October 8, 2025 Project No. 19126620

RESPONSE TO MINISTRY OF NATURAL RESOURCES REVIEW COMMENTS ON PROPOSED HIGHLAND LINE PIT TECHNICAL REPORTS, TOWNSHIP OF LANARK HIGHLANDS, ONTARIO (AGGREGATE RESOURCES ACT APPLICATION #626599)

Upon review of the responses prepared by WSP and Cambium, MNR provided further comments dated March 11, 2025 as part of their objection form (refer to **Attachment 2**). The March 11, 2025 comments provided by MNR are presented below in *italics* followed by the responses by WSP.

**Figure 2: Catchment Areas**

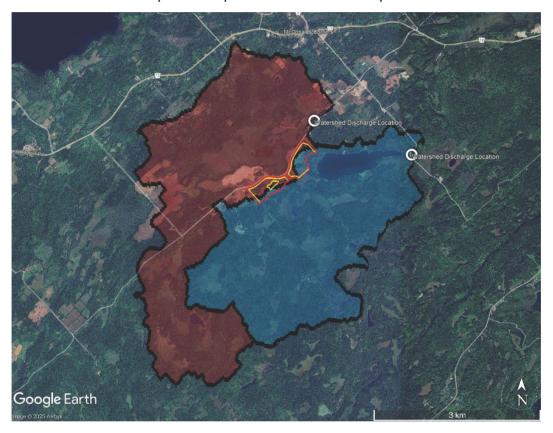
Partially resolved - To address this comment, please provide delineated catchment areas for the adjacent wetlands and watercourses. This mapping should be used to estimate the potential loss of surface water runoff to these features, by comparing water balances within each catchment area (pre- and post-extraction).

As requested, the delineated catchment areas for the wetlands and watercourses adjacent to the proposed Highland Line Pit are provided in Figure 2 below. The catchment areas were delineated using the Ontario Watershed Information Tool (OWIT). Two catchment areas were identified that intersect the site. The catchment to the north (9.6 km²) is associated with the unevaluated wetland to the north as well as the northern branch of Long Sault Creek. The catchment to the south (8.5 km²) is associated with Barbers Lake and the southern branch of Long Sault Creek.

The water balance in the Water Report estimated that the pit excavation will convert approximately 0.20 km² and 0.16 km² of the southern and northern catchments, respectively (approximately 2.4% and 1.7%, respectively) to a depression (pit lake) with a surface outlet to Barbers Lake at 186 metres asl, along the east part of the site, that will both internally drain to shallow groundwater and outflow as surface runoff during different seasons. Although direct runoff from the pit area to either of the catchments will be reduced, the water surplus collecting in the pit will also infiltrate and continue downgradient to Barber's Lake and Long Sault Creek as shallow groundwater flow.

# Revised Figure 2 and Figure 3 from the Water Report

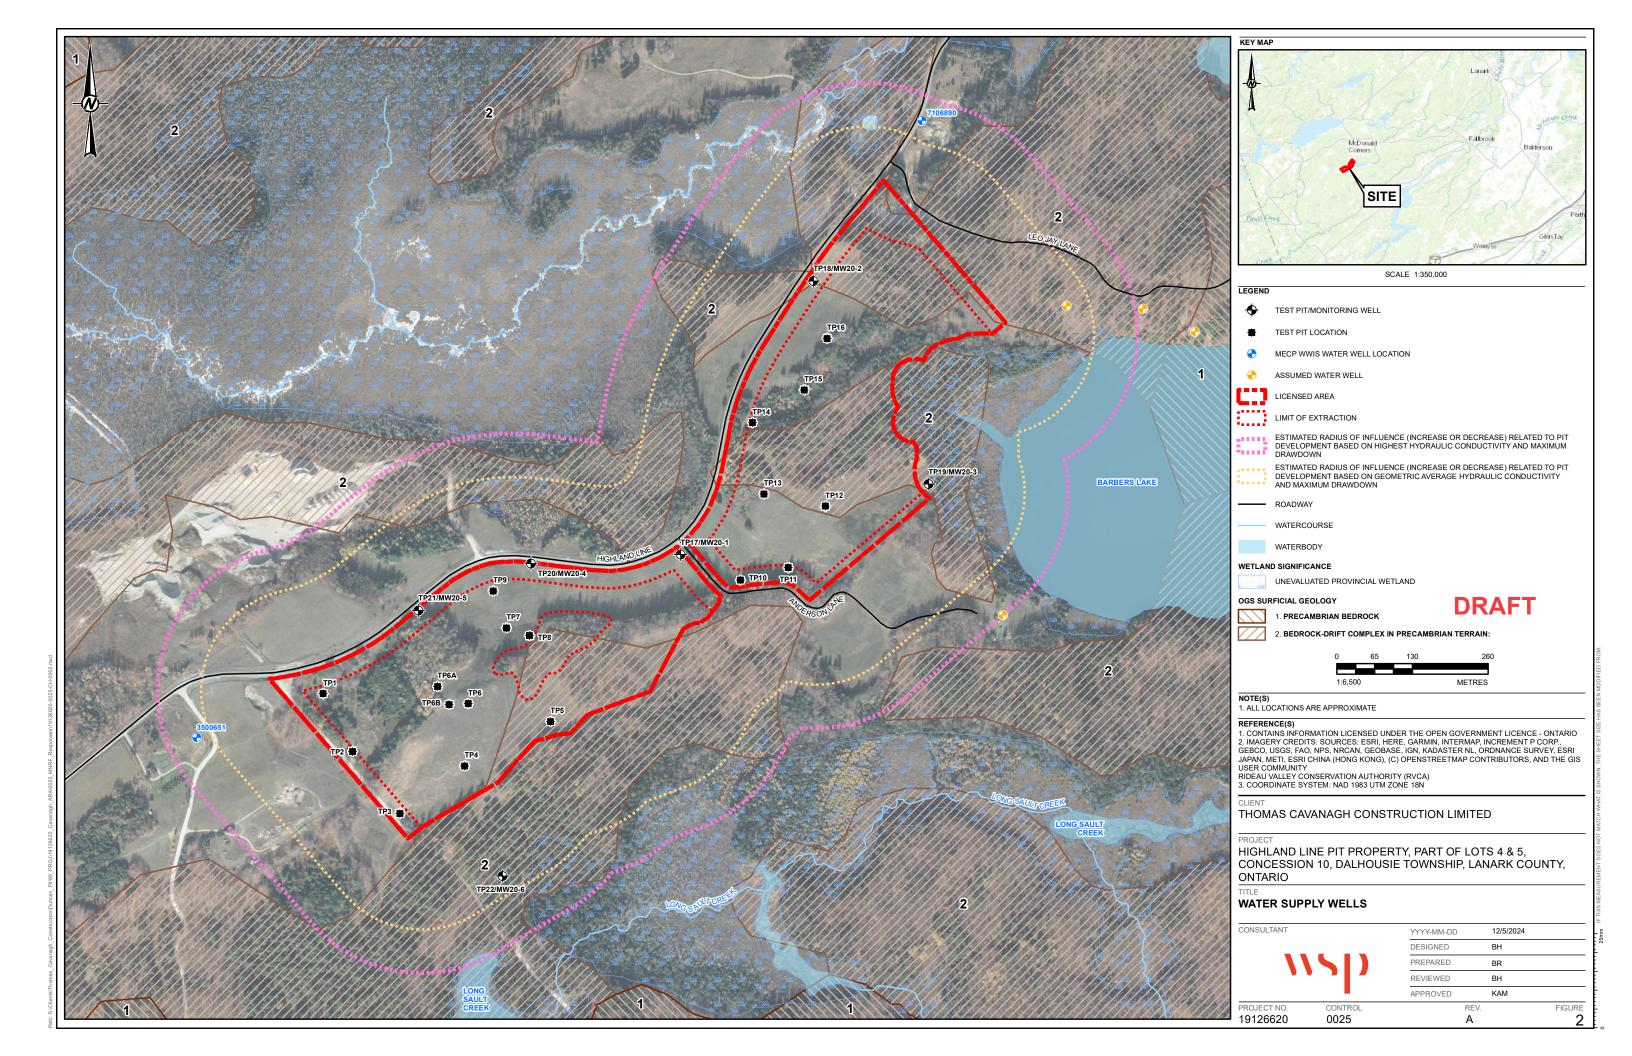
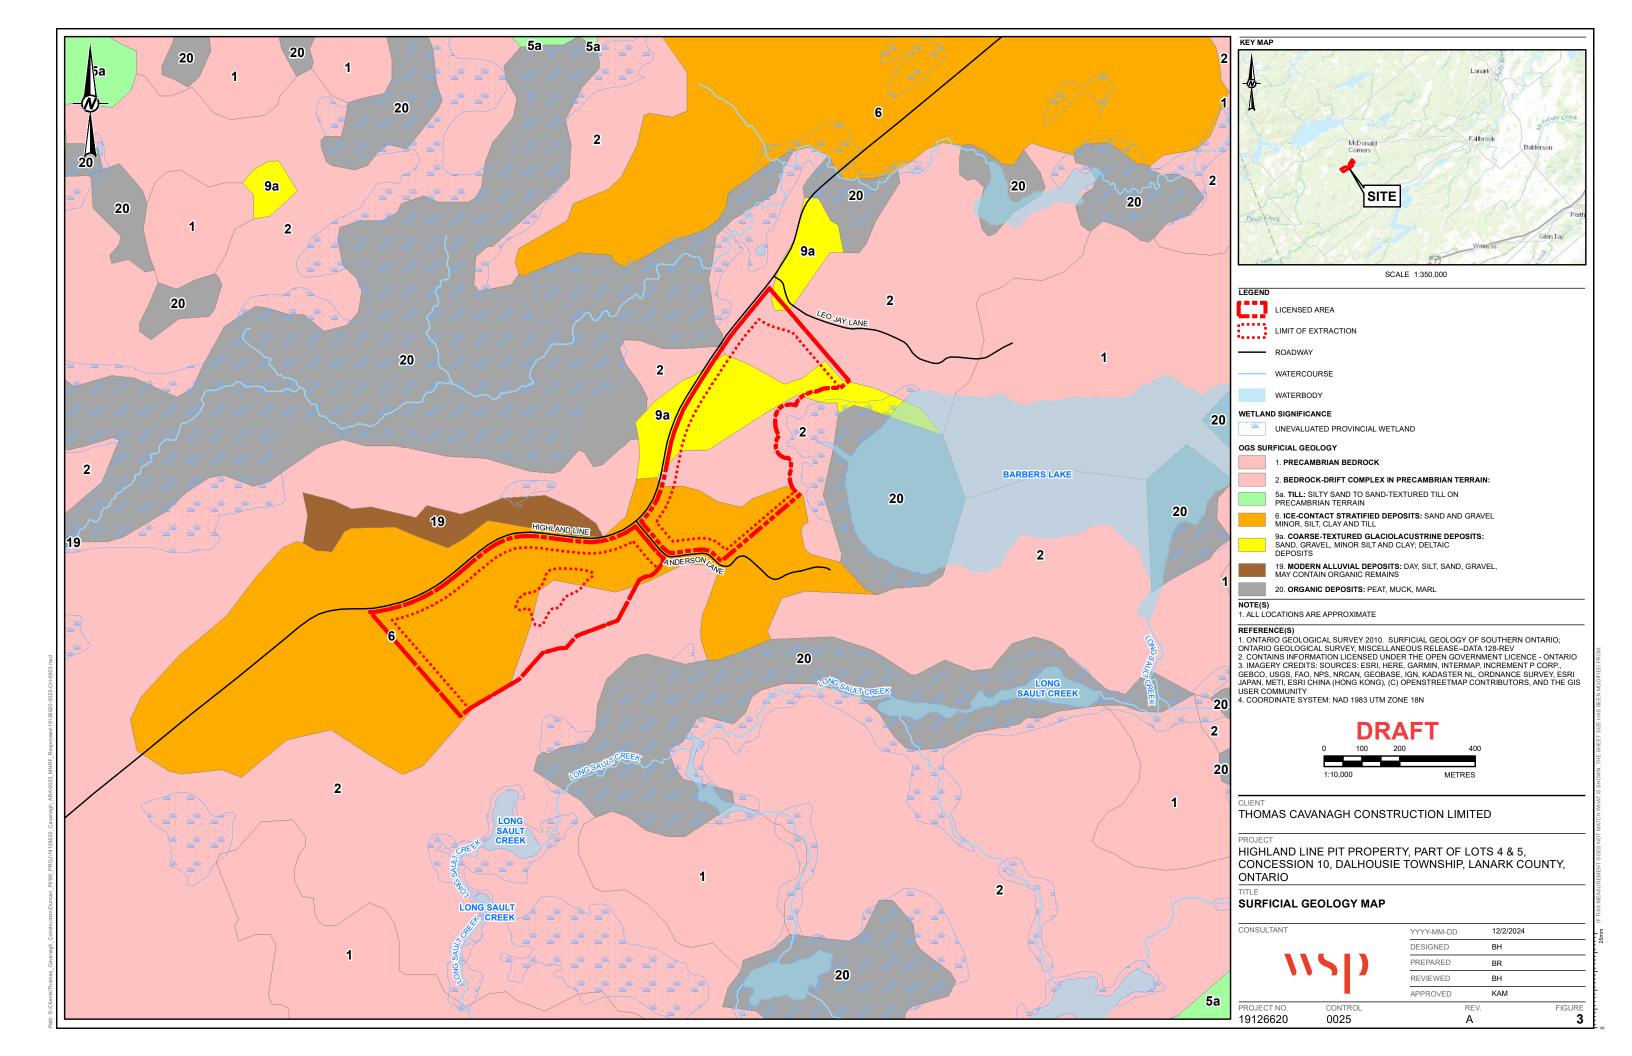
maximum radius of influence based on a 1 m water table change (e.g., revised Figure 2). However, to assess the extent of potential impacts on these features, please provide an estimate of the cone of drawdown with a 0.1 m cutoff. This assessment is important, as even a slight groundwater decline could lead to potential impacts on these features (e.g., coldwater watercourses no longer receiving sufficient groundwater, potentially negatively impacting spawning and incubation areas).

Based on Figure 1A (**Attachment 1**), the overall groundwater gradient across the proposed extraction area is approximately 6 m with the estimated flooded lake level at rehabilitation predicted to be approximately 186 m ASL. As such, this could result in a lowering of the groundwater table on the southwest part of the site and a rise in the groundwater level in the northeastern part of the site adjacent to Barbers Lake. Based on the revised size of Extraction Area 2, the limit of extraction has been setback from the southeast property line of the lands owned by Cavanagh by at least 100 metres thereby increasing the separation distance between the limit of extraction and Long Sault Creek. Based on the reduction in size of the extraction area on the Highland Line property, Figure 2 (Water Supply Wells) from the Water Report has been updated and a revised version of Figure 2 is presented in **Attachment 2**.

Based on the reduction in size of Extraction Area 2 on the Highland Line property, the estimated average radius of influence [based on the one metre of water level change (increase or decrease) related to pit development] does not propagate beneath the Long Sault Creek along the south part of the site (northeast of MW20-6). This is illustrated on the updated version of Figure 2 from the Water Report which is presented in **Attachment 2**.

PROJECT NO. CONTROL REV. DRAWING 3 OF 5 19126620 0014

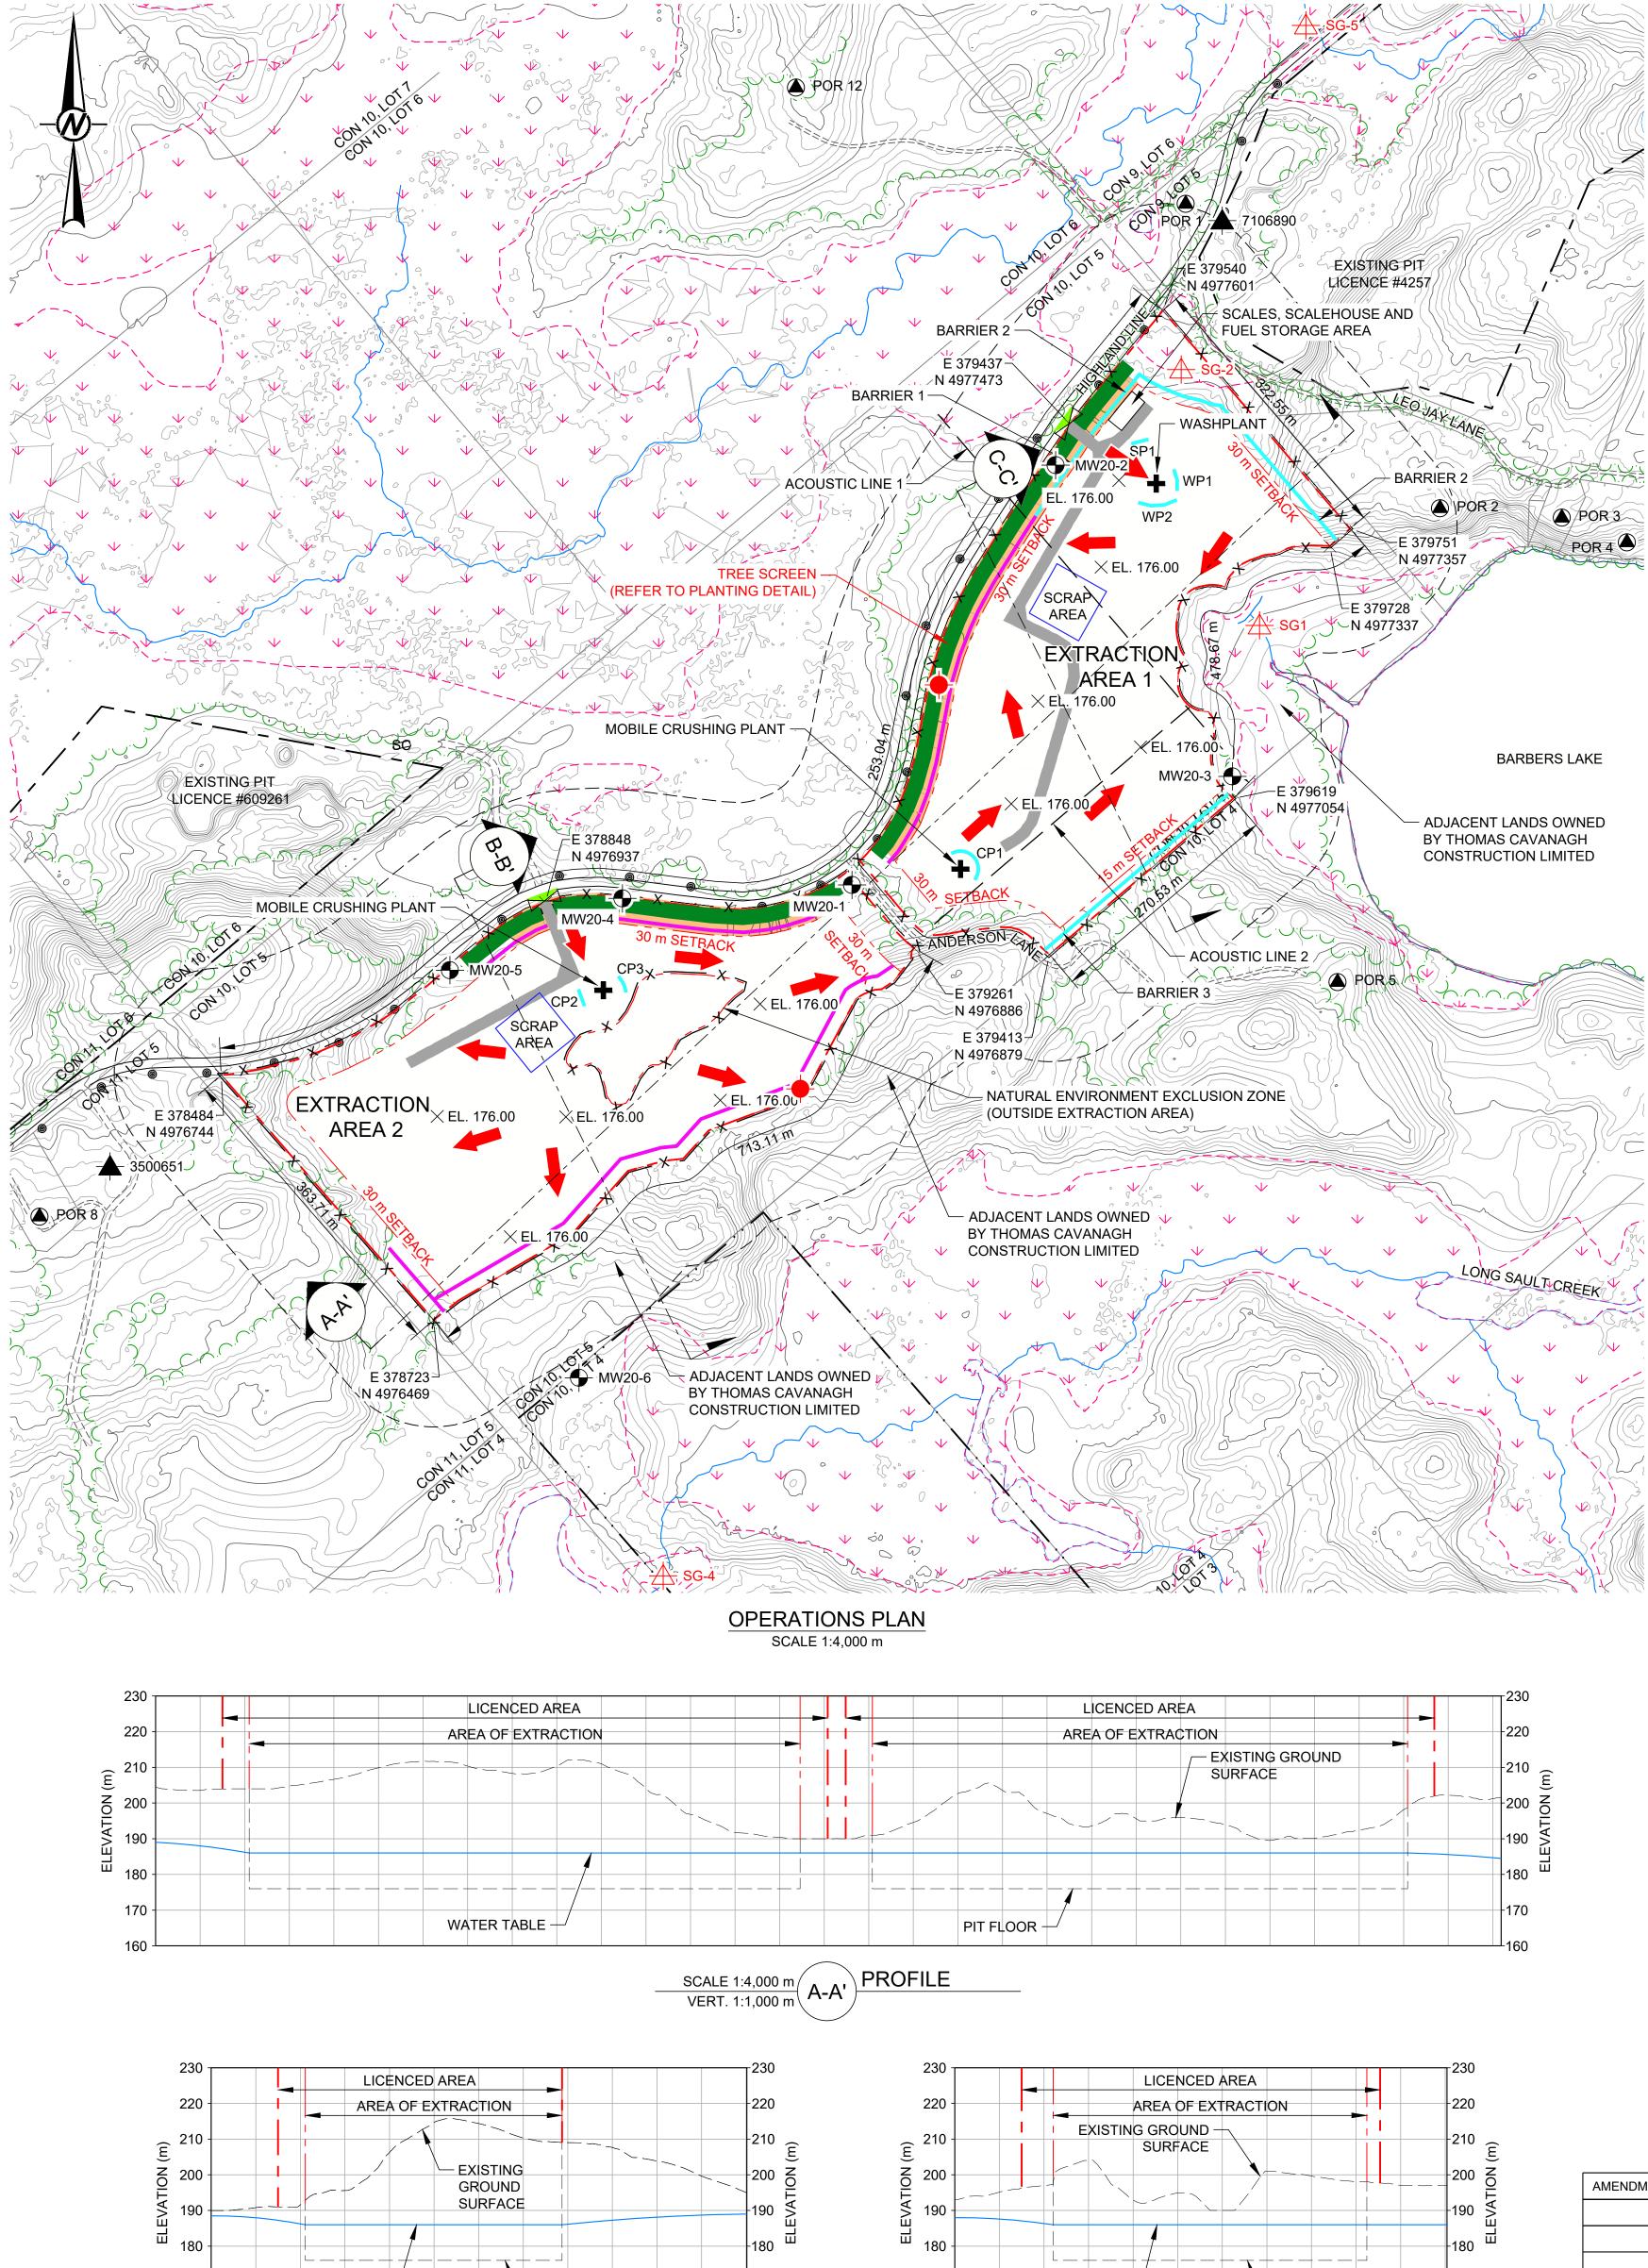
Partially resolved – To improve the clarity of the site plan, please include the area to be excavated in the setback in the legend on page 3 of 5.

Partially resolved - To confirm the impact assessment for the adjacent wetlands and watercourses, including monitoring the performance of any mitigation measures (e.g., setbacks etc.), it is recommended that the groundwater and surface water monitoring program on the site plan be enhanced to include:

- Installing additional monitoring wells.
- Establishing additional surface water monitoring stations.
- Incorporating SG2 into the monitoring program.
- Increasing the frequency of water level readings.
- Establishing trigger thresholds at the monitoring locations and developing an adaptive management plan/response plan.

The area to be excavated along Highland Line Road to provide a clearer line of sight is shown on the Operations Plan (page 3 of 5) and the symbol has been included in the legend on the Operations Plan (page 3 of 5).

- In order to provide additional information regarding potential changes to water levels in the wetland located to the north of the site, an additional monitoring well is proposed in the area between Anderson Lane and the existing MW20-2. Similarly, to monitor groundwater levels to the south of the site, an additional monitoring well is proposed between MW20-6 and Anderson Lane, adjacent to the extraction area. Proposed monitoring well locations are presented on the Site Plans (Page 3 of 5) in **Attachment 6**.
